14. Wastewater Memo

TECHNICAL MEMO – WASTEWATER SPECIALIST INPUT

To:	Lucia Taluga
From:	Robyn Floyd, Senior Wastewater Specialist
Approved by:	Rod Dissmeyer, Team Leader, Stormwater, Wastewater & Industrial Trade, Specialist Unit
Date:	13 March 2020

Wastewater Discharge Consent Variation Application Number: DIS60084241-A

WASTEWATER SITE PLAN FOR CURRENT APPLICATION (CADVIZ Sheet EF1 Rev 9', dated 20 February 2020)

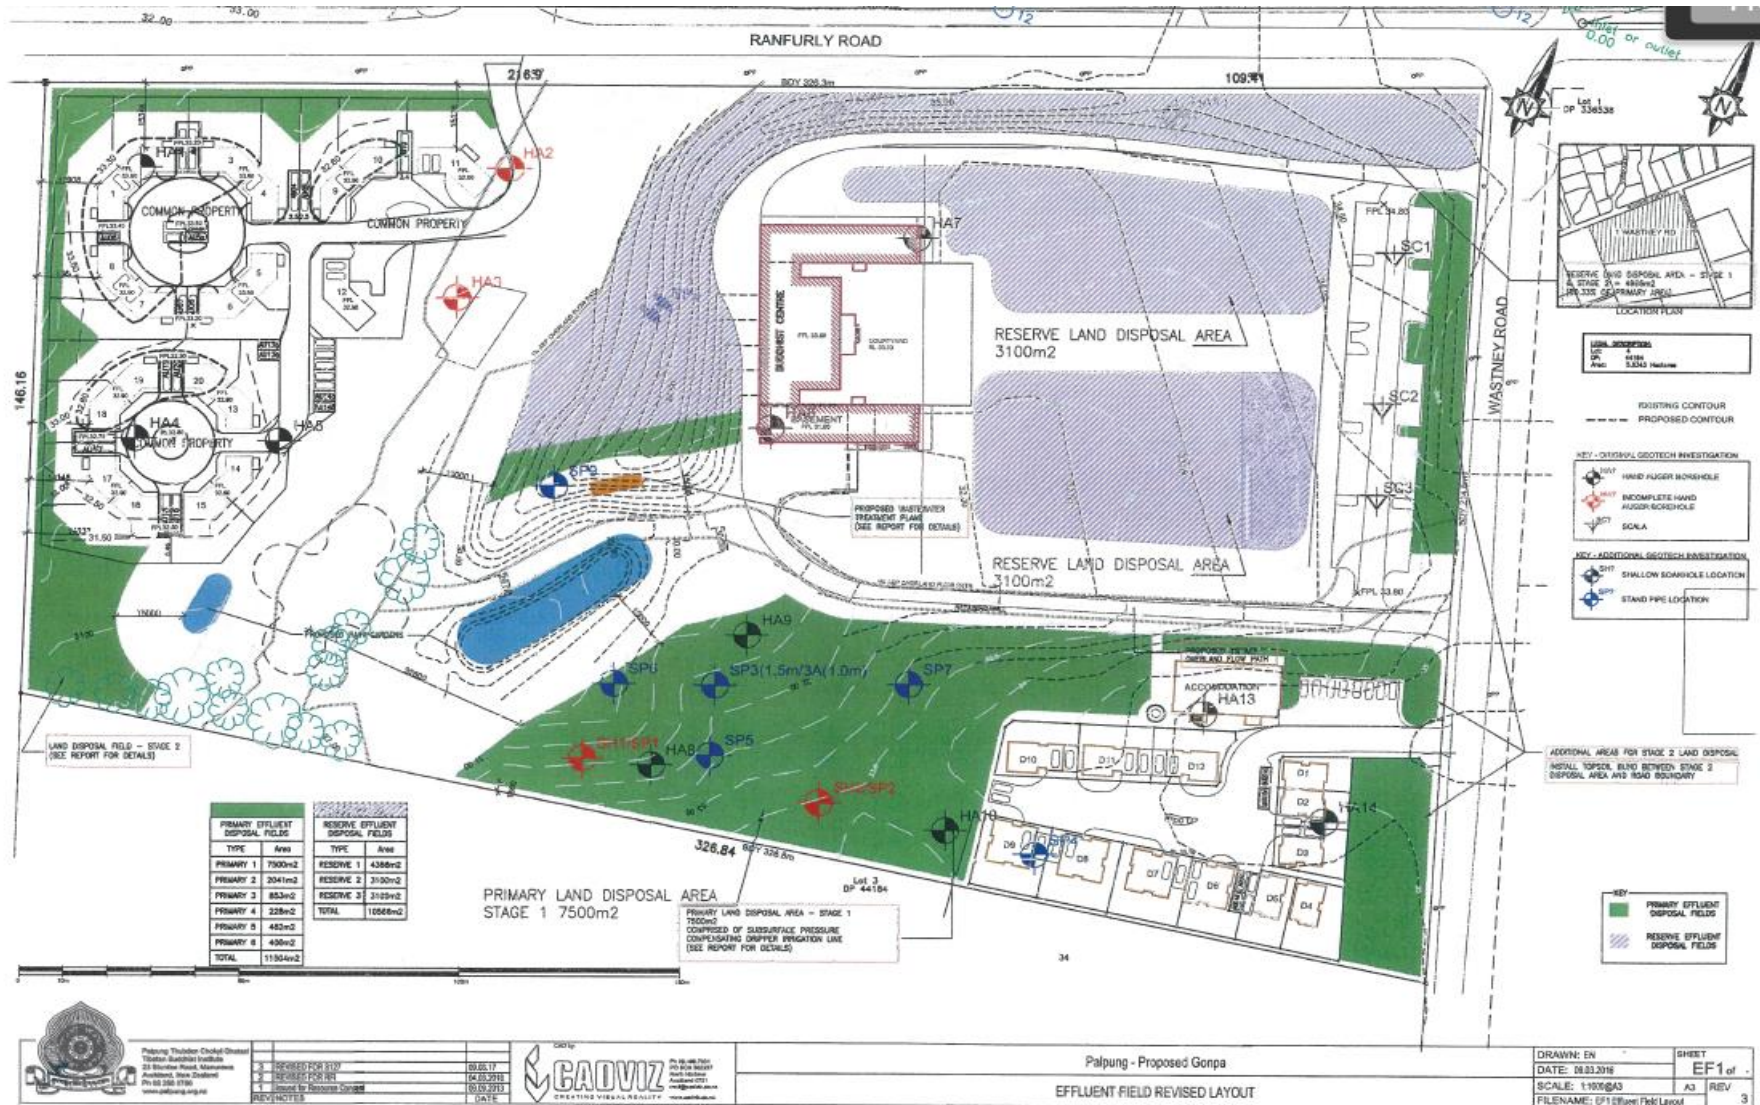
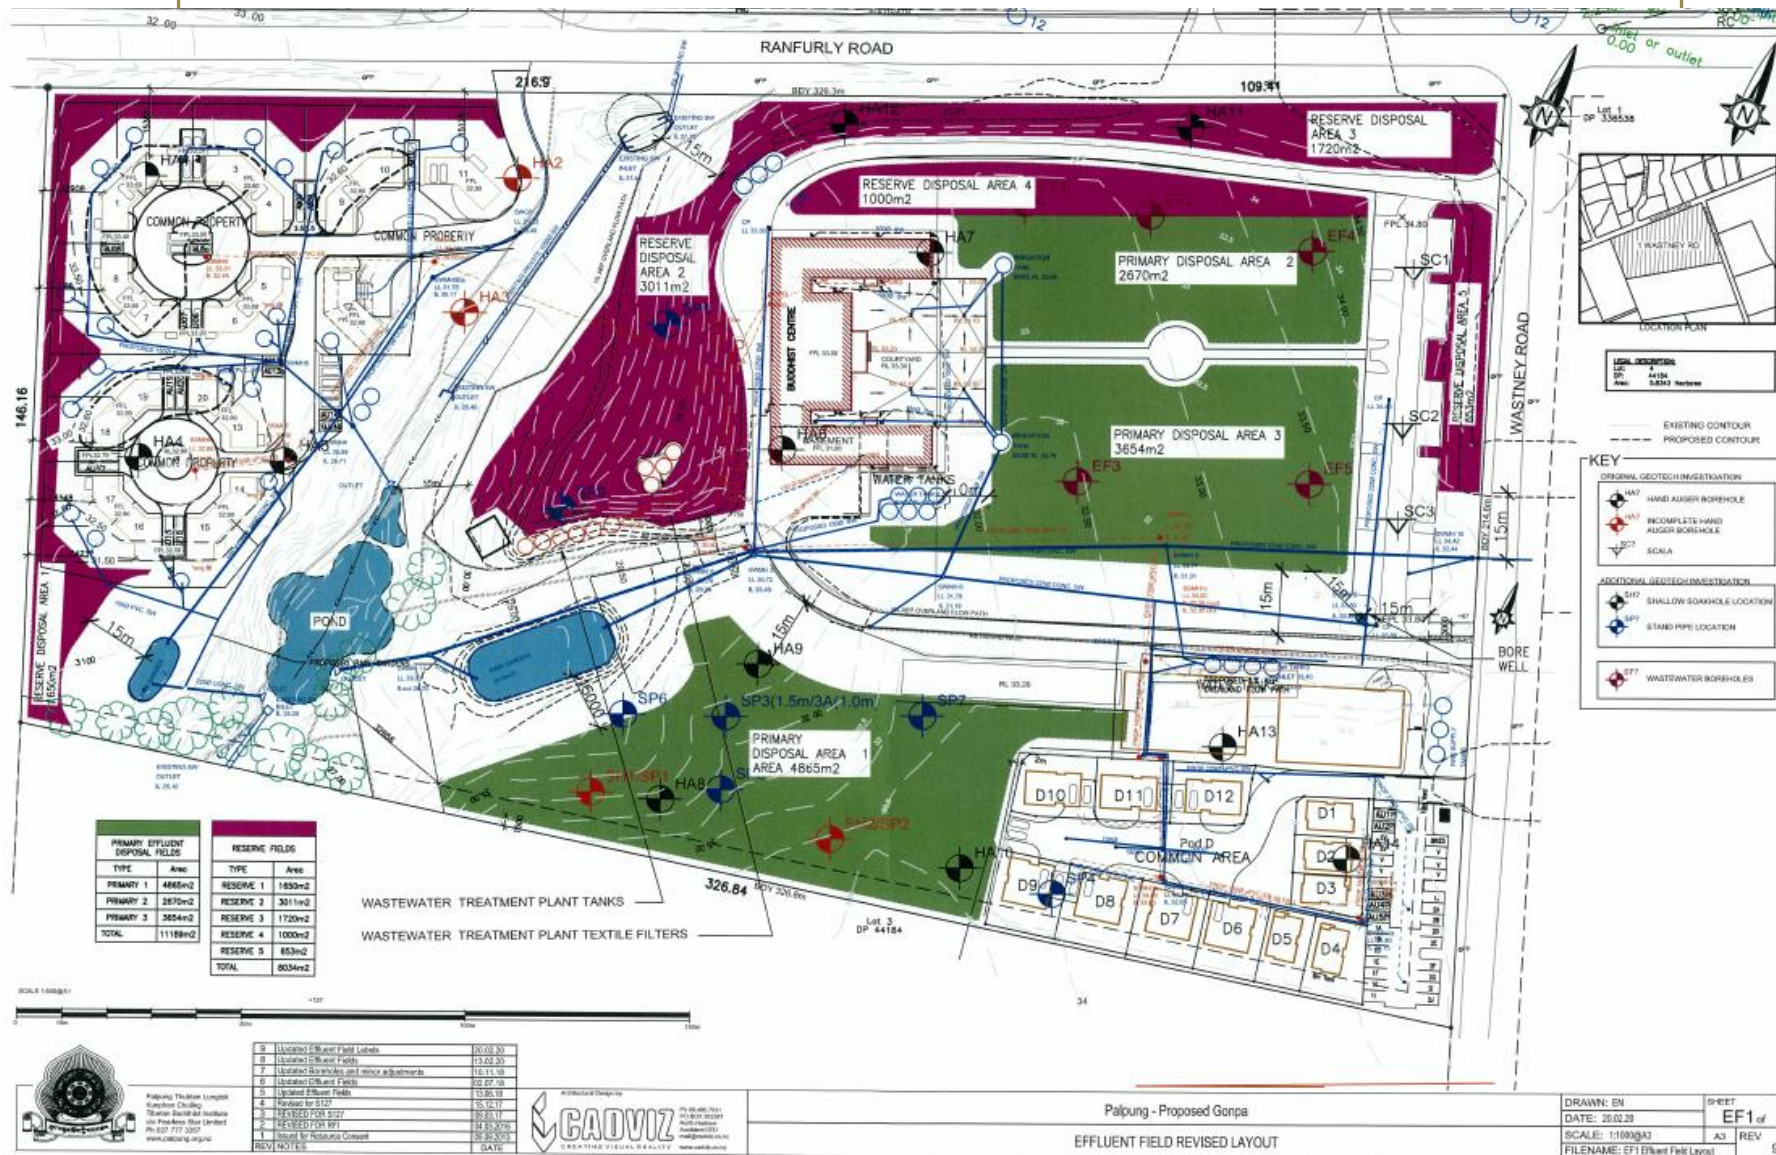
Significant changes are proposed to the layout of the sections of the primary wastewater *irrigation disposal system* and locations of the various reserve areas. The total primary area is decreasing by 104m or less than 1% in the revised proposal which is accepted as marginal and the reserve area is decreasing from 90% to 72%.

Parts of the reserve areas lie very close to site boundaries and on filled land which could reduce its soakage capacity, in addition to roadside drains and community cluster areas. There is at least 72% reserve area which means there are options in which part/s should be used if required. The conditions also require that a change to the discharge consent is obtained if use of the reserve area for disposal purposes is required. This provides an opportunity for adequate assessment to be undertaken if it is required.
